# Access Compliance Report

### (Curb Ramps)

Intersection ID: 30263	Main Street: BLYTHEDALE_DR	Cross Street: FORTESCUE_DR	Location: E
ADA ID: 5783CD9C8616	Ramp Type: PerpDiag	Initial Pass/Fail: Fail	Overall Compliance: No
		Severity Score: 12.5

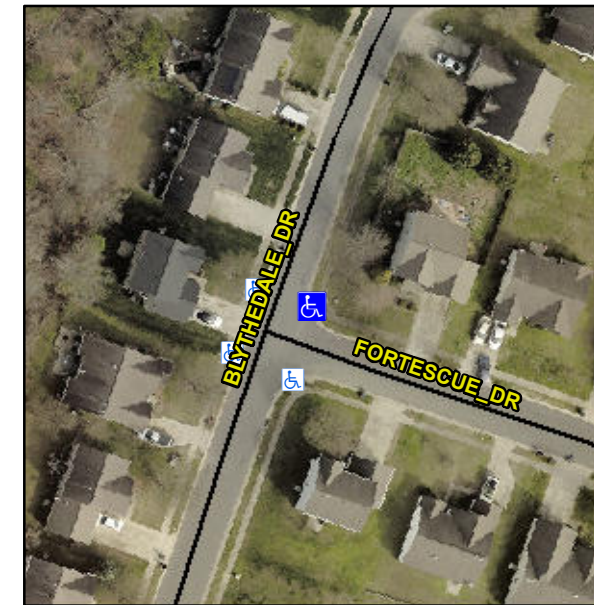
**Not Found, R304.5.3**

Compliance	Description	Data	Compliance	Description	Data
N/A	Ramp Length (in)	48.0	Yes	Ramp Slope (%)	5.1
Yes	Ramp Width (in)	48.0	No	Ramp XSlope (%)	5.2
N/A	Flare Type LT	N/A	N/A	Flare Type RT	N/A
N/A	Flare Slope LT (%)	N/A	N/A	Flare Slope RT (%)	N/A
N/A	Flare Traversable LT?	N/A	N/A	Flare Traversable RT?	N/A
N/A	Landing Length (in)	N/A	N/A	DWS Provided?	N/A
N/A	Landing Width (in)	N/A	N/A	DWS Contrast?	N/A
N/A	Landing Slope (%)	N/A	N/A	DWS Length (in)	N/A
N/A	Landing X Slope (%)	N/A	N/A	DWS Full Width?	N/A
N/A	Landing Curb? (Y/N)	N/A	N/A	DWS Offset (in)	N/A
N/A	Shared Landing?	N/A			
N/A	Gutter Ponding?	N/A	N/A	Gutter Slope (%)	N/A
N/A	Gutter Lip Ht (in)	N/A	N/A	Gutter X Slope (%)	N/A
N/A	Painted X Walk1?	No	N/A	Painted X Walk2?	No
	X Walk 1 Direction	To N		X Walk 2 Direction	To S
N/A	X Walk 1 Width (in)	N/A	N/A	X Walk 2 Width (in)	N/A
	X Walk 1 Slope (%)	6.5		X Walk 2 Slope (%)	5.2
	X Walk 1 X Slope (%)	4.0		X Walk 2 X Slope (%)	0.4

**Remove & Replace Curb Ramp With Two New Directional Ramps or Equivalent.**
